INVITATION FOR BIDS (IFB) No. 026-009

BROAD RUN EXPANSION SPECIAL TRACKWORK MATERIALS

QUESTIONS AND ANSWERS

NORFOLK SOUTHERN RAILWAY COMPANY
NO. 8 132/136RE TURNOUT
WITH 16'-6" SWITCH, S.M.S.G.
FROG AND SWITCH POINT GUARD
SEPTEMBER 1996
Atlanta, Georgia

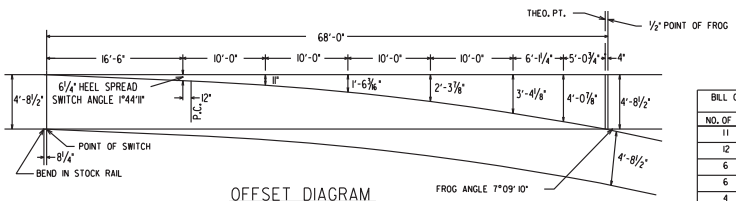
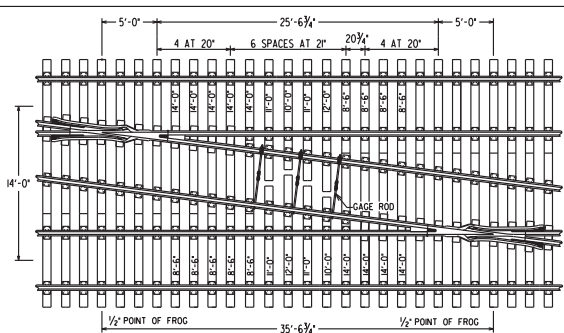
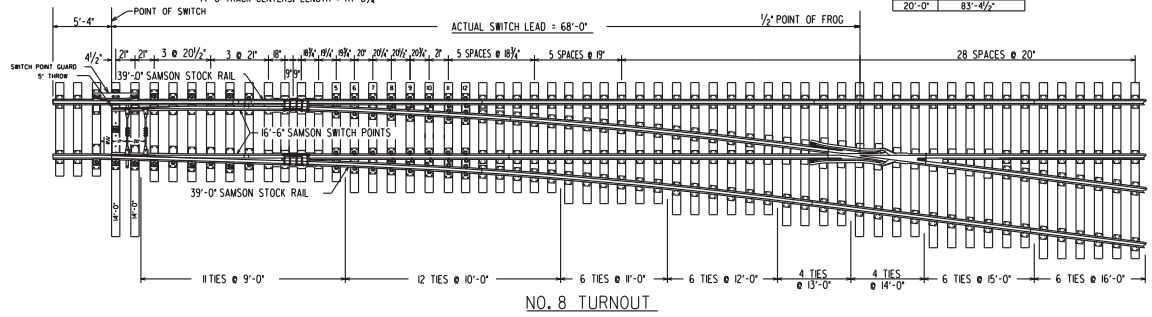
8. The drawings on VRE’s website look like they are of the overall project. Do you have any drawings of the actual trackwork? Also, do you know what specific type of Alstom 5 switch machine is required?

9. Seems the bid is missing some drawings. If possible, could we please be supplied with the drawings noted in Section 34 11 23 Special Trackwork Section 1.3 A. Reference Standards 3. NSRC Standard Plans a.

Refer to the following Norfolk Southern Railway Company drawings attached hereto:

Plan 2-4: No 8 Turnout
Plan 2-12: No 15 Turnout
Plan 7-9: Switch Point Derail
